Development Review Board (DRB)
Review Comments
Utility Development Section
Reviewer: Blaine Carter, P.E.
Phone: 505.415.9188

DRB Project No: PR-2021-005927	Date: 09/01/21	Item No: #13		
Zone Atlas Page: F-11	Legal Description: Lot(s) LOT 4, LANDS OF OBLESTER ROMERO			
	Location: 4732 WESTWARD LN between ATRISCO DR and NORTHERN TRAIL			
Request For: PS-2021-00104 – SKETCH PLAT

PS-2021-00104 – SKETCH PLAT

1. CREATE 3 LOTS FROM ONE EXISTING LOT

14-16-5-1(C)(2) Contextual Residential Development in Areas of Consistency

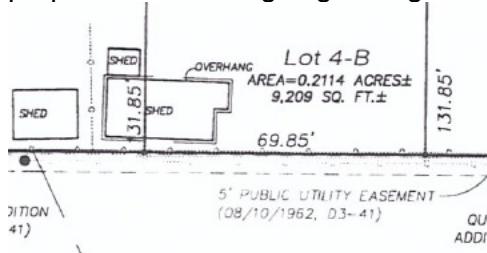
Area of consistency
